**RE: Sightline Review – Road A, Windgate Drive Access  
 Beaver Bank, Nova Scotia**

As per your request, WSP has reviewed the provided topographic survey data along Windgate Drive and the surrounding area within the vicinity of the proposed access road to Windgate Village. This memo outlines our review of topographic survey data with respect to the minimum stopping sight distances required along Windgate Drive to the proposed development access.

Figure 2 – Sightline Review

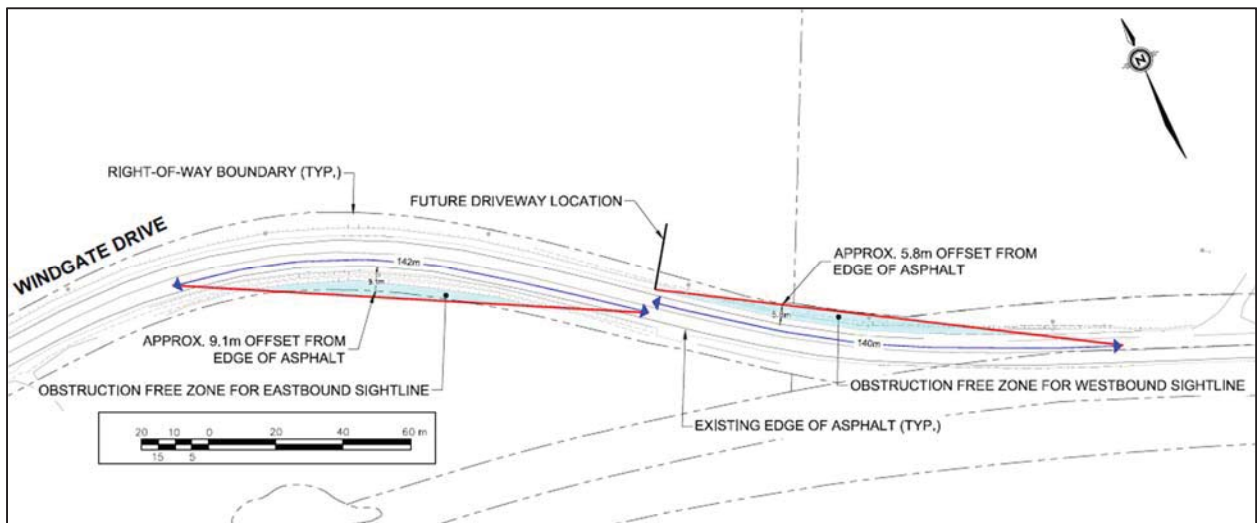
The approaches along Windgate Drive require the following stopping sight distances:

- The eastbound approach will require 140 m of unobstructed sightlines in order for a vehicle to make a controlled stop travelling 80 km/h on a -1% (downhill) grade; and,
- The westbound approach will require 142 m of unobstructed sightlines in order for a vehicle to make a controlled stop travelling 80 km/h on a -2% (downhill) grade.

Upon review of the recently acquired topographic survey data, it was determined that adequate stopping sight distances will be available for the eastbound and westbound approaches along Windgate Drive with some tree clearing and regular maintenance (See Figure 2). The obstruction-free zone for the eastbound sightline is expected to be 9.1 m offset from the edge of asphalt near the midpoint, as shown in Figure 2. It should be noted that the outlined obstruction-free zone encroaches beyond the existing right-of-way. The obstruction-free zone for the westbound sightline is expected to be 5.8 m offset from the edge of asphalt near the midpoint, as shown in Figure 2. The driver eye and object heights were plotted and compared to the elevation profile from the topographic survey data. Based on the surface review, it was determined that the existing roadway profile will not impede driver sightlines. In addition, sightline clearance beyond removal of vegetation is not expected to be required.

In conclusion, adequate stopping sight distance is expected to be available on Windgate Drive towards Road A with the recommended tree clearing west and east of the propose site access road.
